# Access Compliance Report

## Public Rights-of-Way

### (Pedestrian Signals)

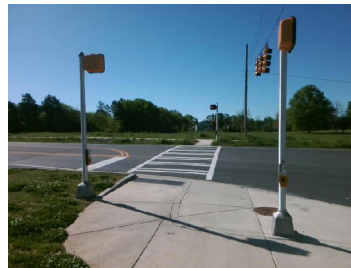
Intersection ID: N/A	Main Street:	Cross Street: N/A	Location: N/A
ADA ID: 2B6D599FC73C	Signal Type: One Push Button-APS	Overall Compliance: No	Severity Score: BTN 1: N/A BTN 2: N/A No BTN: N/A
Codes/Mitigation Info/Possible Solution		Field Measurements/Component Compliance

PROW/ADA: TMUTCD 4e.08, R404.2, R404.3, R209.1, MUTCD 4e.10

Possible Solutions: Replace Signal Push Button With APS Button on New Post. Remove & Relocate Sign.
